REVISIONS	
Addendum No. 2	5/14/2009

**CITY OF NEWPORT NEWS**  
**DEPARTMENT OF PUBLIC UTILITIES**  
**NEWPORT NEWS, VIRGINIA**  
**LEE HALL**  
**MAINTENANCE AND OPERATIONS CENTER**

**SECOND LEVEL FLOOR**  
**PARTIAL PLAN PART C**  
**NEW WORK**  
 Drawing No.  
**ME-4**

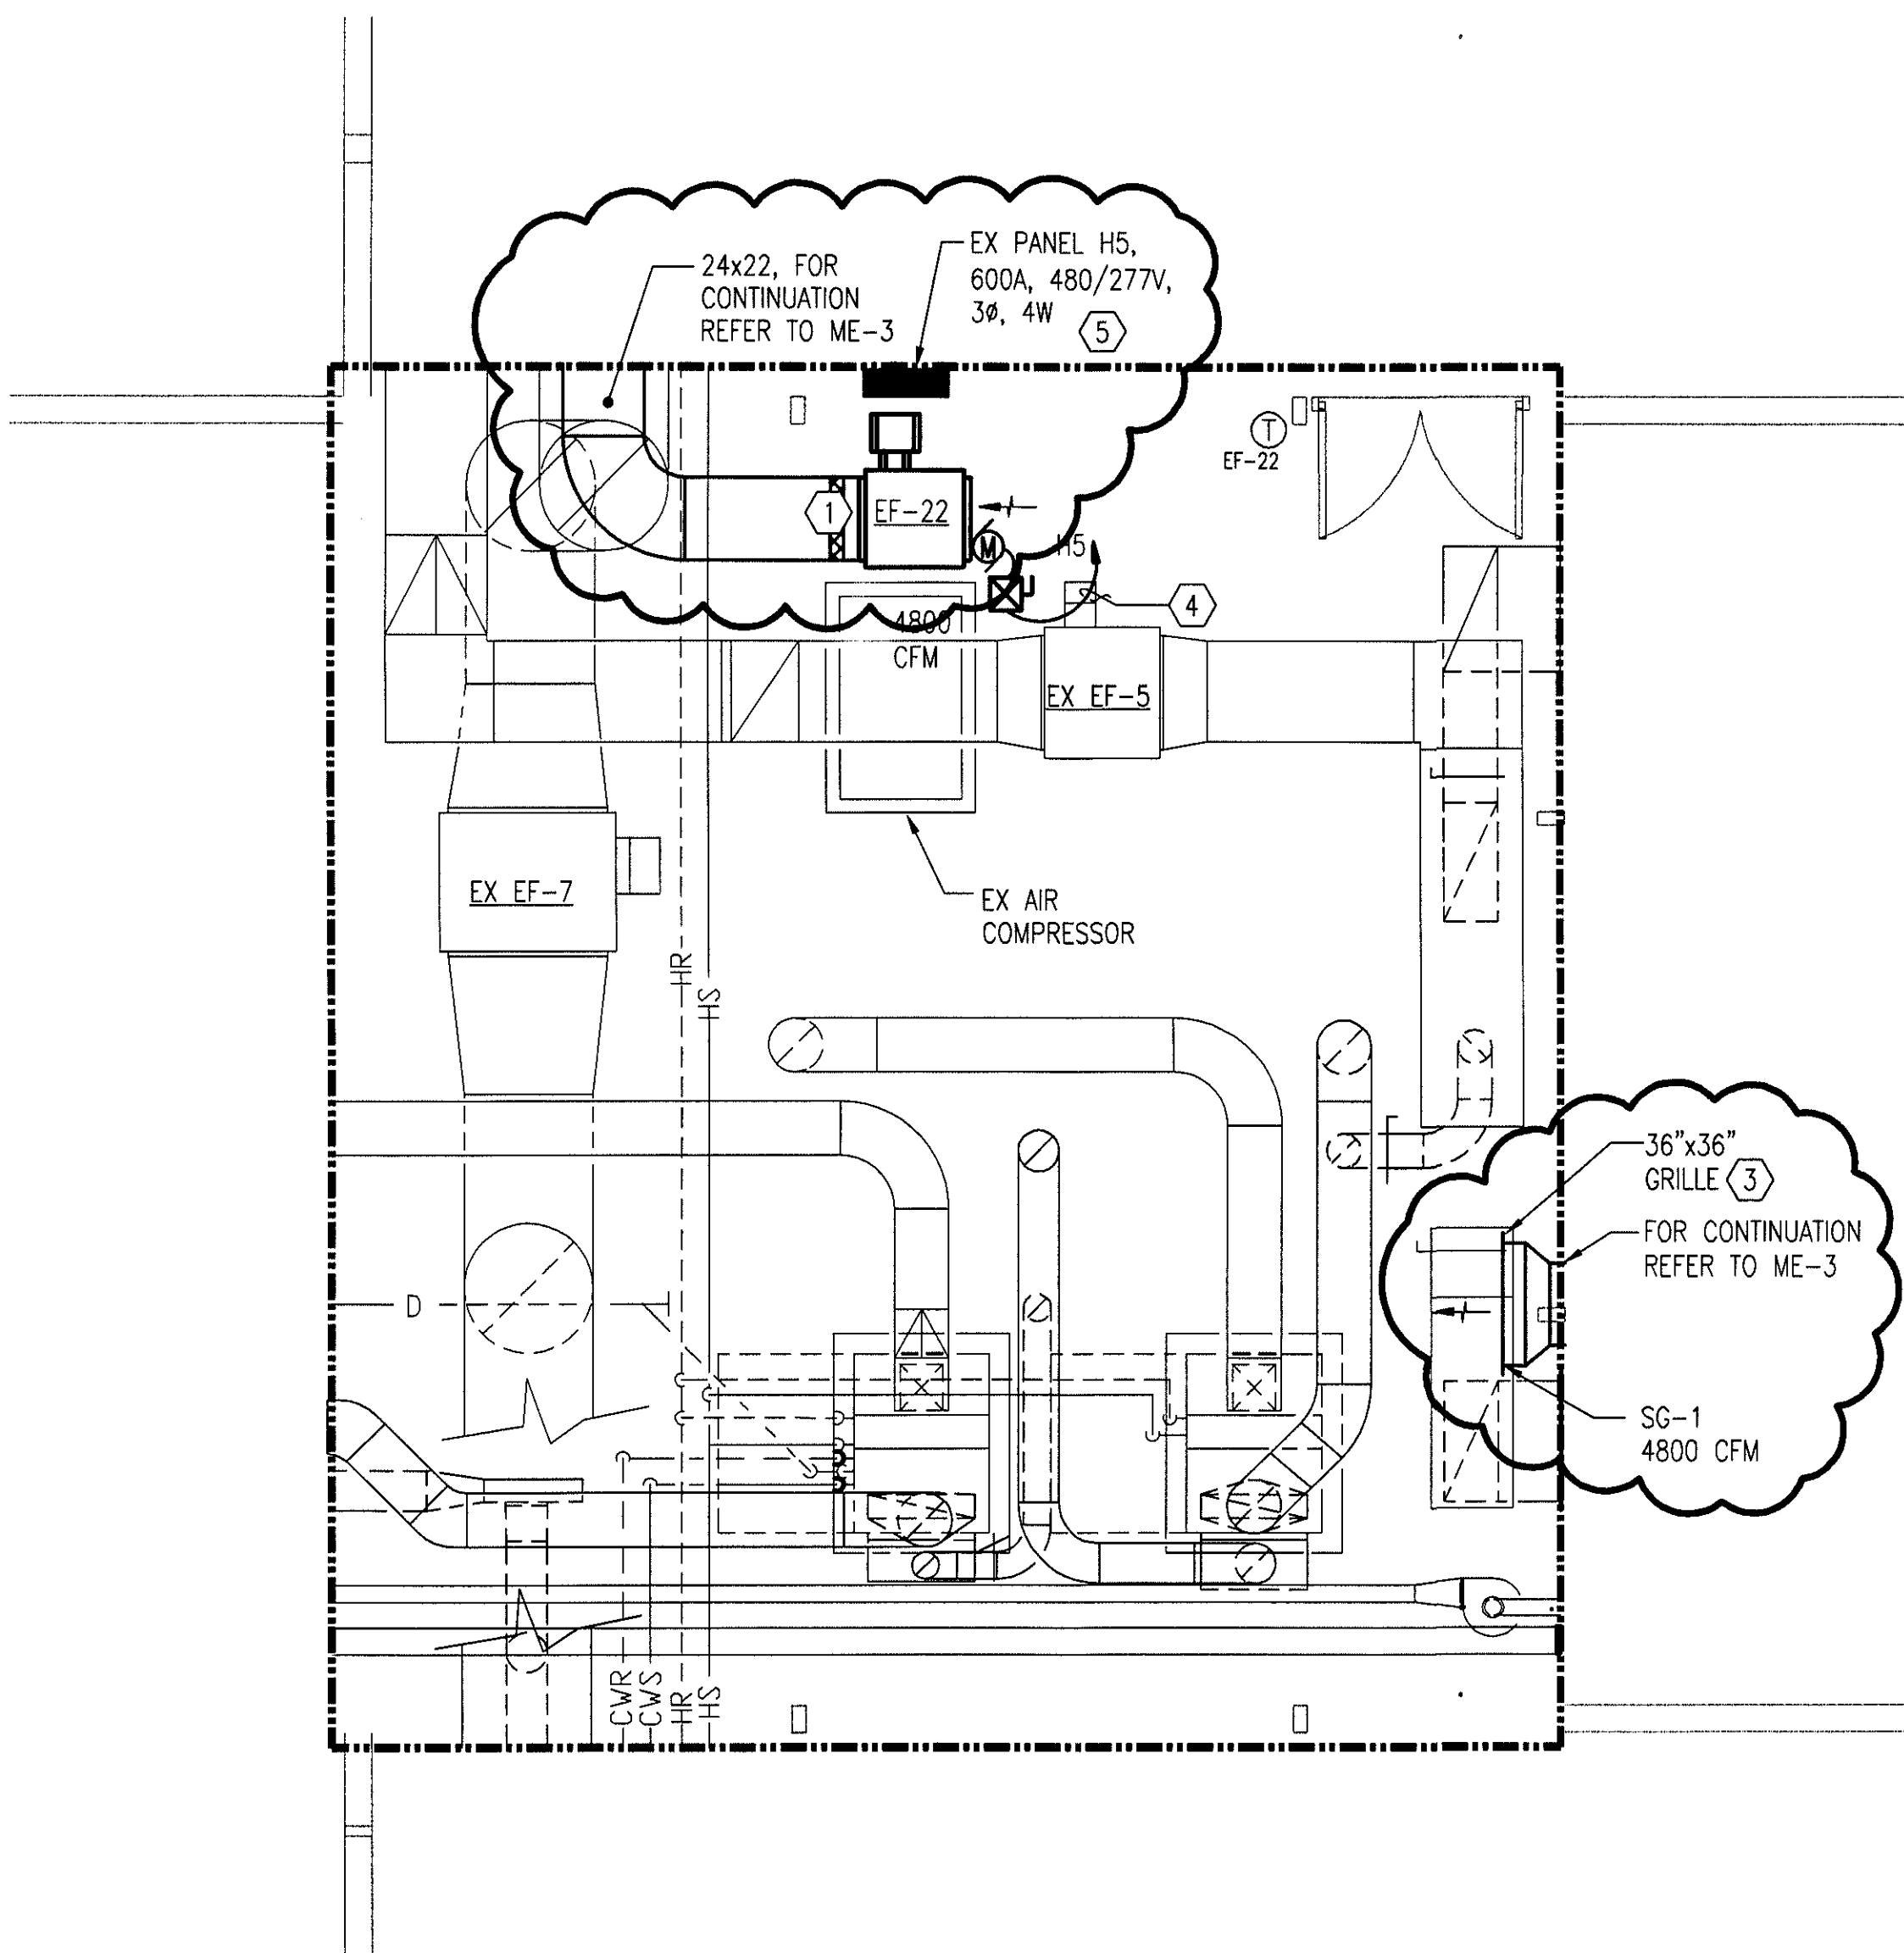
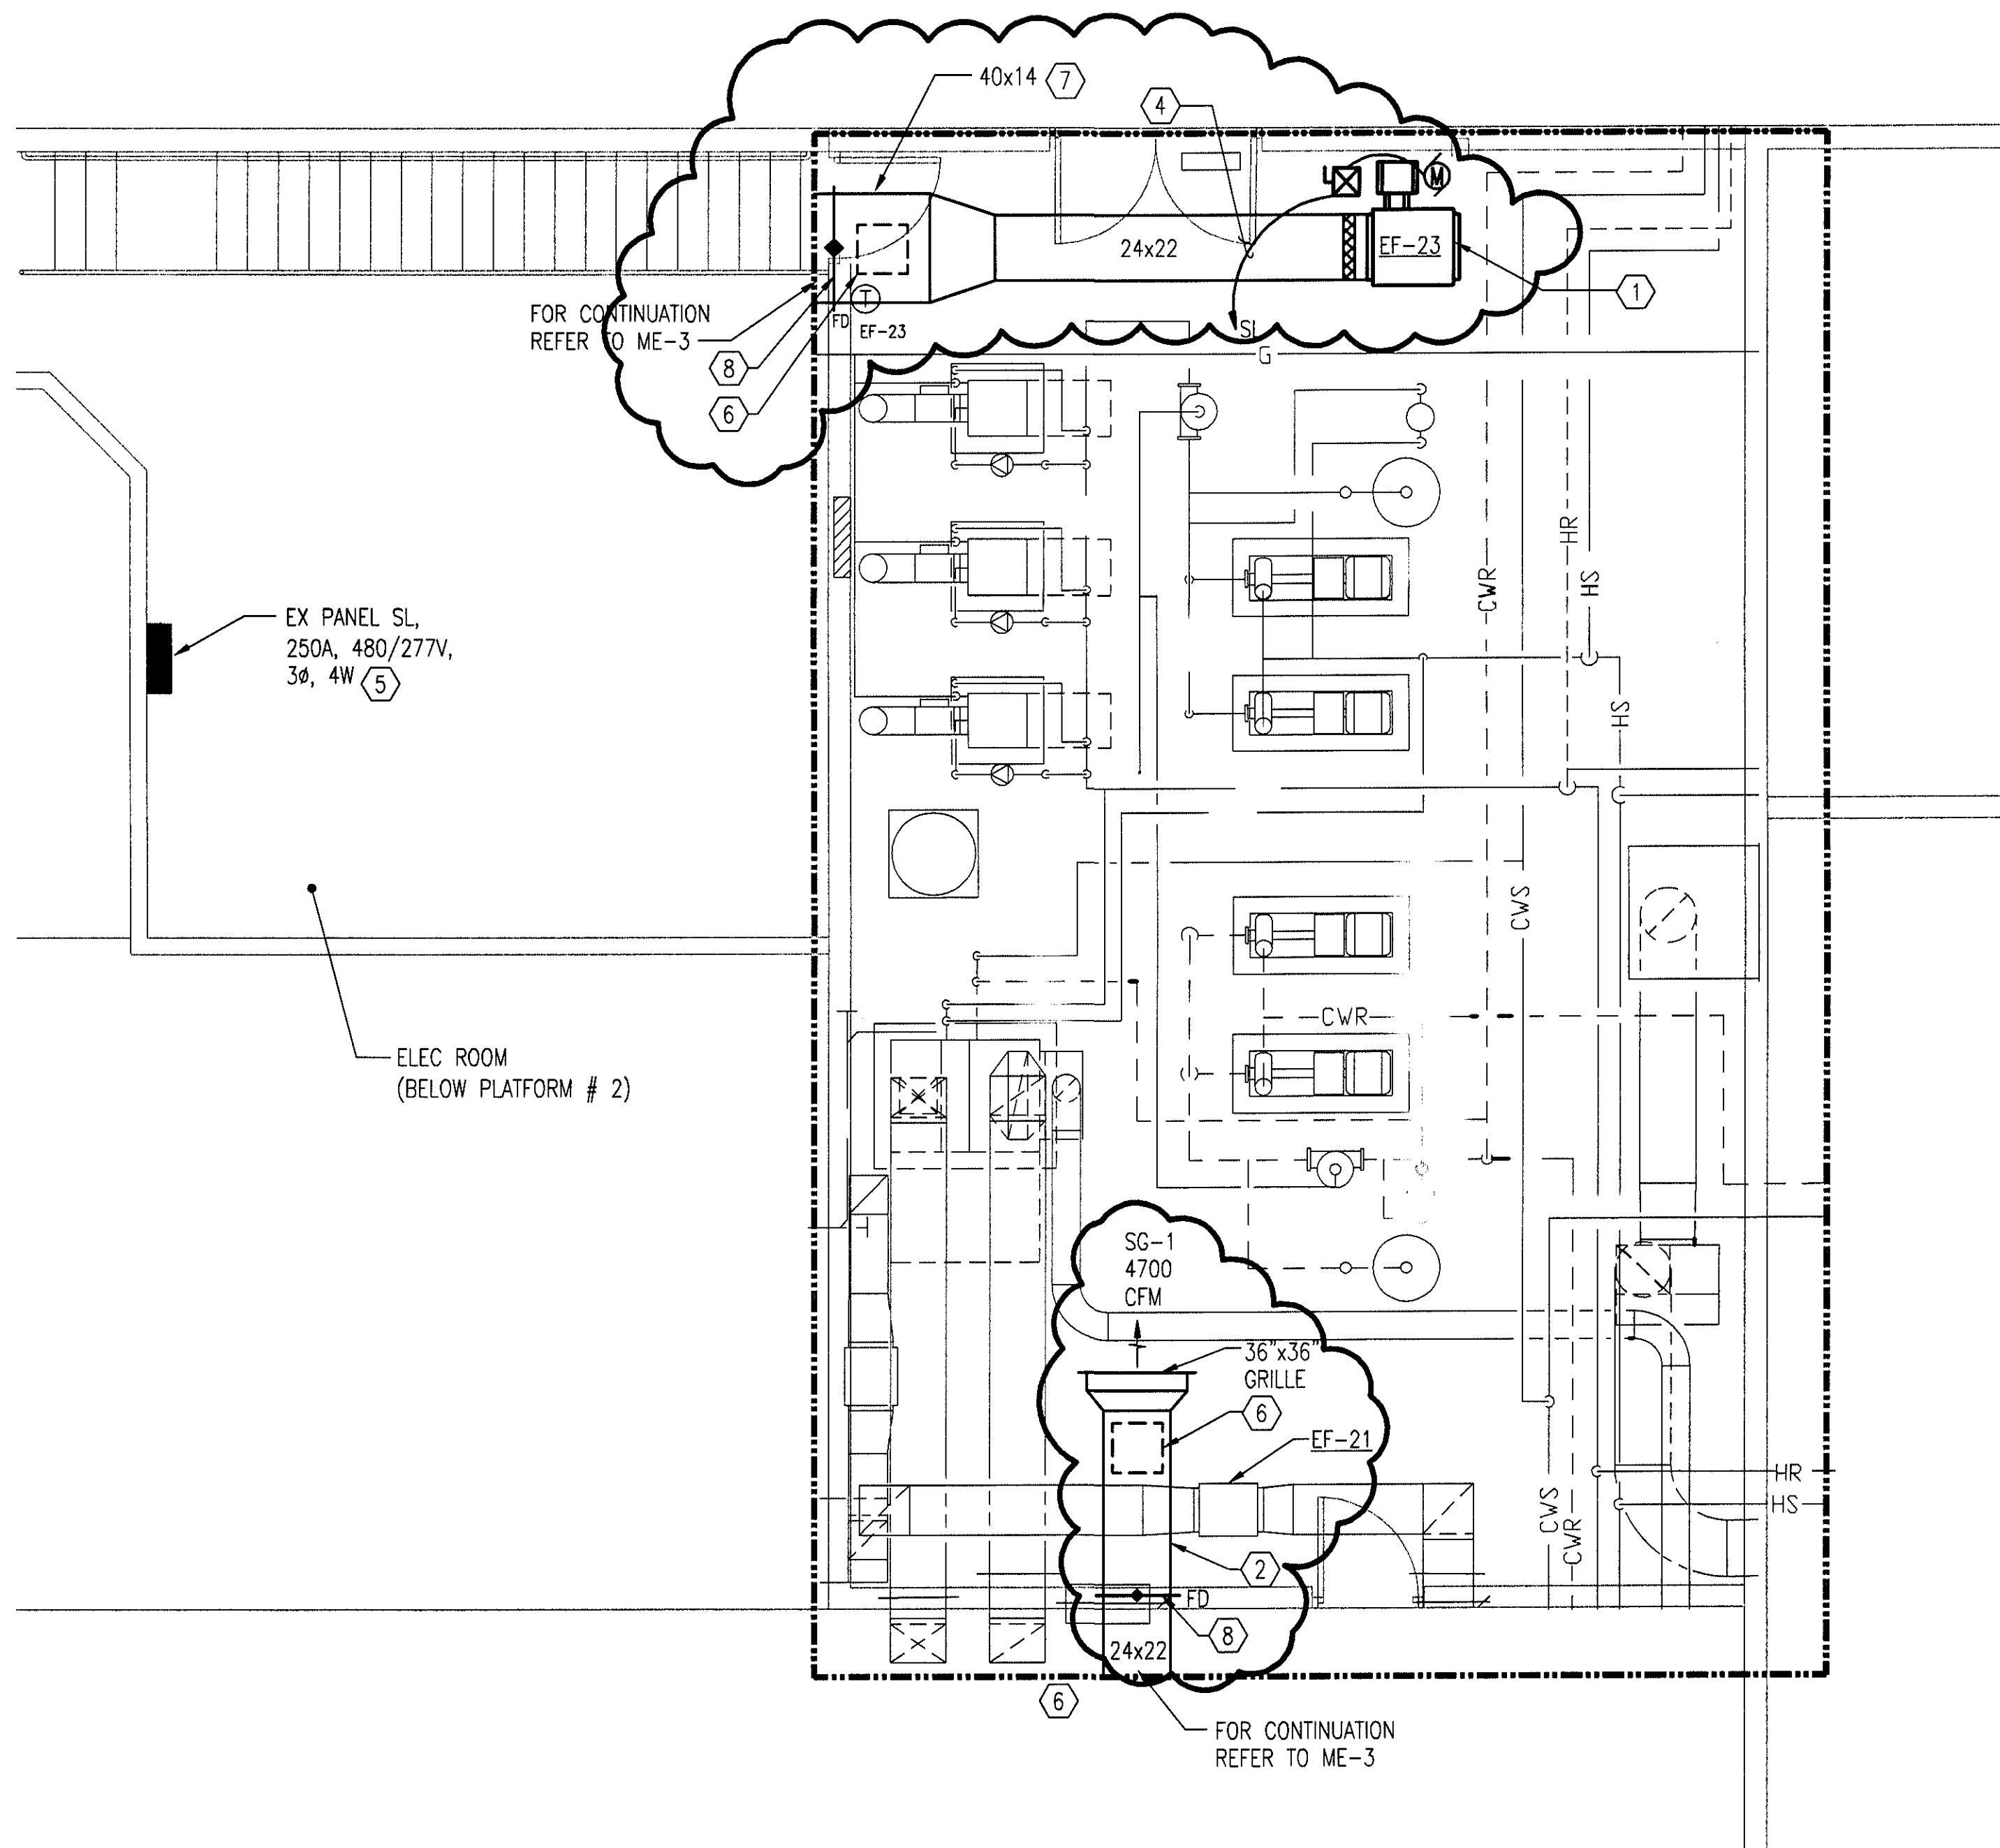
- 1 PROVIDE IN-LINE EXHAUST FAN AND LOCATE 9 FEET AFF.
- 2 DUCT SHALL RUN ABOVE EF-21. LOCATE GRILLE AND DUCT TO AVOID EF-21 AND HANGERS.
- 3 SUPPLY AIR GRILLE SHALL BE LOCATED 9 FEET AFF.
- 4 3#12 & 1#12 G - 3/4" C.
- 5 PROVIDE 3P-15A CIRCUIT BREAKER IN EXISTING PANEL AND CONNECT TO NEW CIRCUIT, CIRCUIT BREAKER SHALL MATCH EXISTING.
- 6 PROVIDE 18"x18" DUCT ACCESS FOR FD ACCESS. MAINTAIN CLEARANCE BELOW DOOR FOR ACCESS.
- 7 TRANSITION DUCT TO RUN BETWEEN CONDUITS IN MECHANICAL ROOM.
- 8 FIRE DAMPER SHALL BE 1 1/2 HOUR RATED CURTAIN TYPE AS MANUFACTURED BY RUSKIN MODEL D1BD OR EQUAL.
